**Subject: Revised Site Plans  
Notice of Intent: Multi-Family Residential Project  
505 Main Street  
Sturbridge, MA 01518**

On behalf of the STL Group, Graves Engineering, Inc. (GEI) is submitting these revised site plans pursuant to ongoing discussions with Rebecca Gendreau to address concerns relative to the proposed bioretention area. In summary, the site plans have been revised as follows:

**NARRATIVE**  
**REVISED 01/24/24**

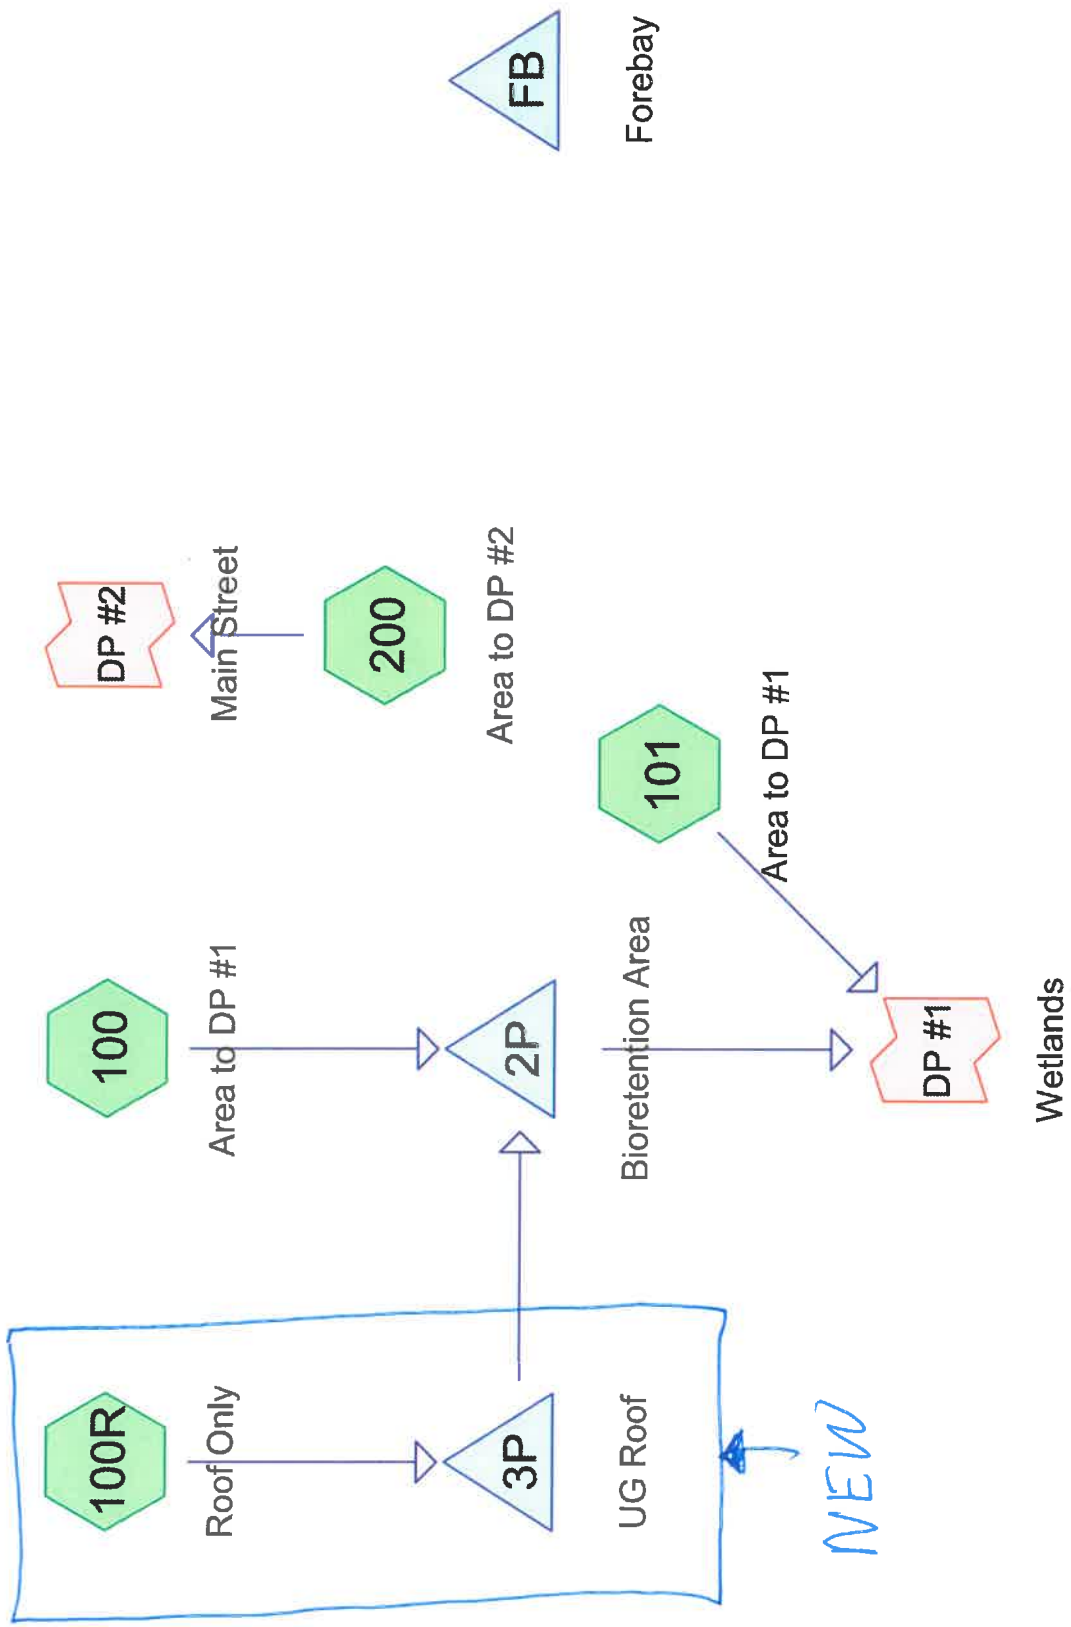
**25-Foot Wetland Buffer Restoration Area**

This project includes restoration of previously disturbed areas within 25 feet of the southerly wetlands. Refert to Sheet C103 of the site plans and the capture below for the location and signage associated with the Restoration Area:

The restoration area must be allowed to be in a natural state with no mowing, pesticide or herbicide treatments. Signage shall remain as shown in perpetuity.
